From:
Sent: 24 March 2021 18:50
To:
Cc: Planning
Subject: Ladycross plantation - NYM/2019/0731/AD

Wall structure as per Studio Stead drawing 101/06/01

Stone wall

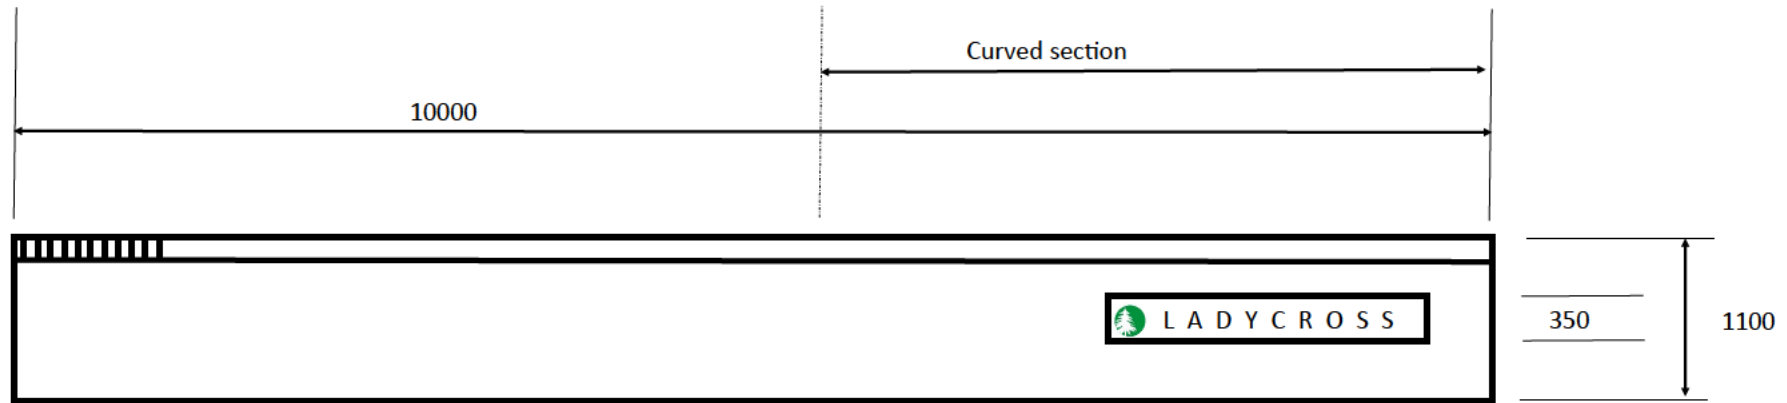
To have coping stone and stonework not pointed to have a drystone wall form

Lighting

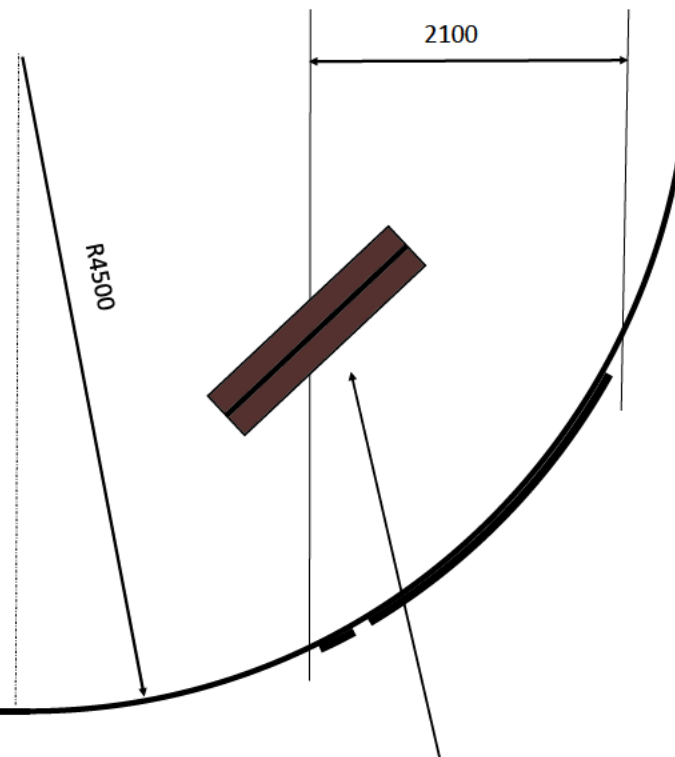
No lights mounted to the wall or in the ground in front of the wall

Sign positioned approx 2 mtrs back
